REMARKS

Applicant : Jan Andersson et al.
Serial No. : 10/673,689
Filed : September 29, 2003
Page : 13 of 13

Attorney's Docket No.: 06275-131002 / BRS/A1721-1P
US

Amendments to the Drawings:

Fig.13

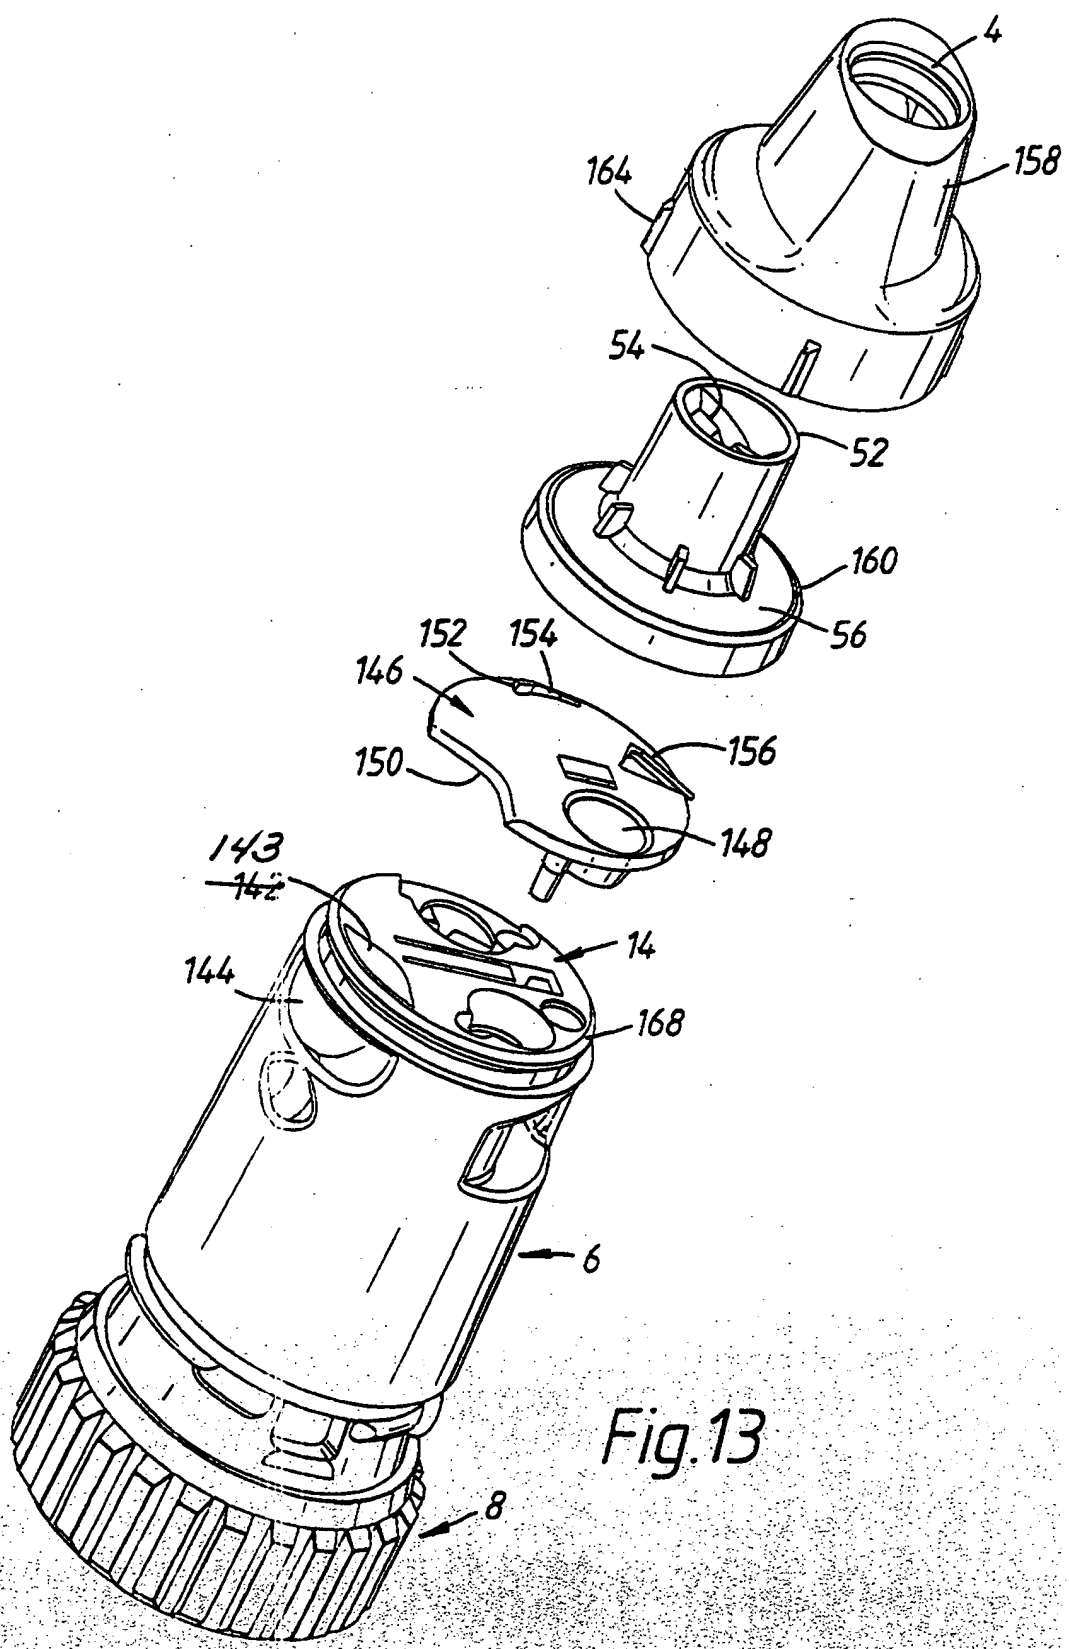
In Figure 13, reference number 142 which points to the supplementary air inlet has been changed to reference number 143. The specification has been amended to reflect this change.
